## DEVELOPMENT REVIEW COMMITTEE (DRC) COMMENT REPORT

**PROJECT NAME:** Icon 0706

**CASE NUMBER:** R18034

**REQUEST:** Site Plan Level II Review: 83 Multifamily  
Residential Units in Northwest Regional Activity  
Center

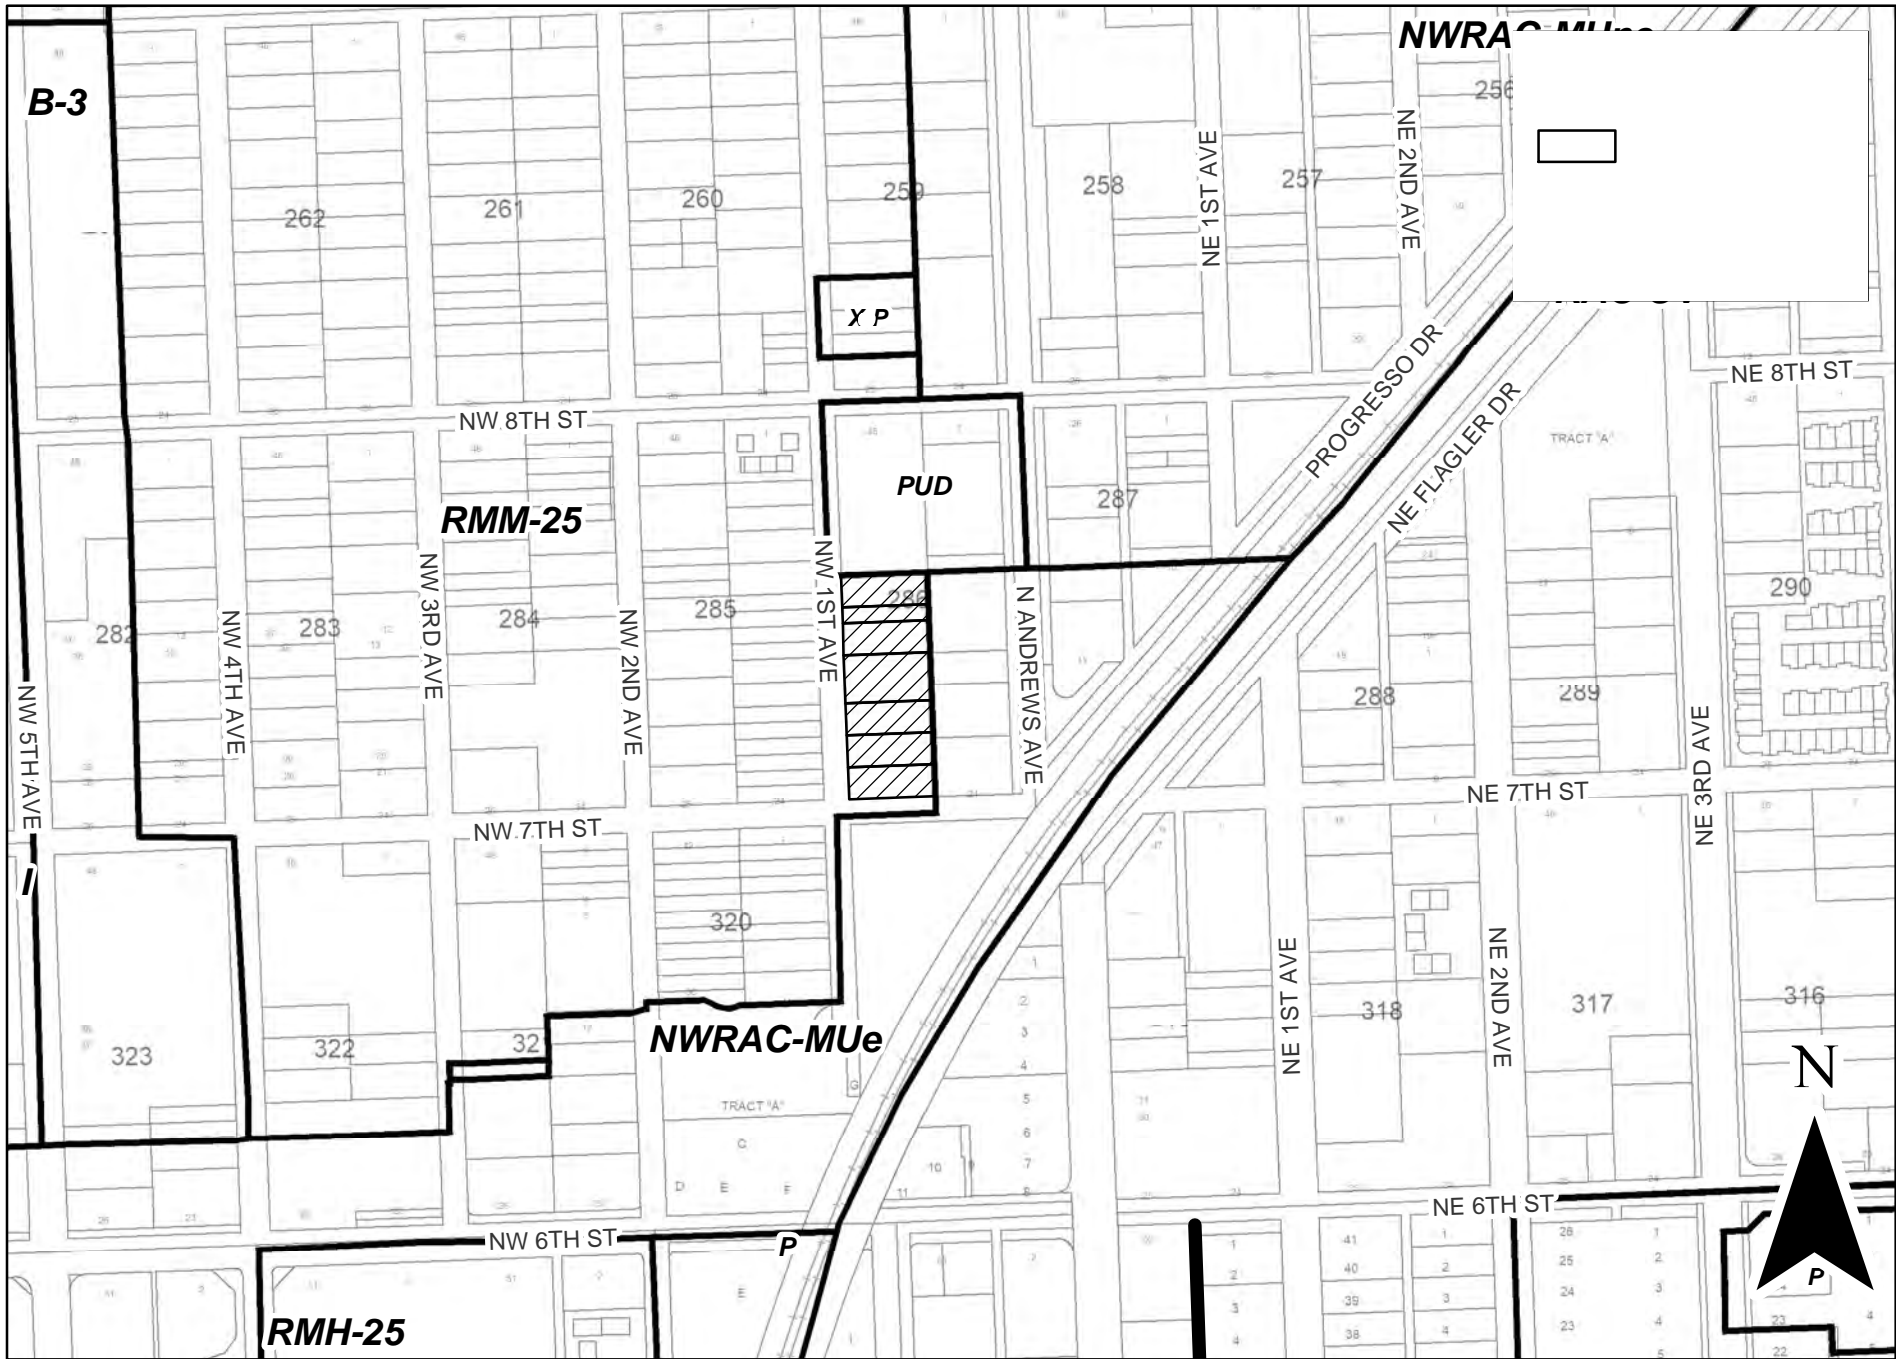
17. Pursuant to ULDR, Section 47-13.31 and NWRAC Illustrations of Design Standards page 4.3, the maximum height permitted by right in the NWRAC-MUe (east of NW 2<sup>nd</sup> Avenue) is 120-feet. However, please keep in mind that the height and massing needs to meet the other regulations regarding floorplate maximums, podiums, stepbacks, setbacks, etc. and be within the building envelope. Please provide a street cross-section.
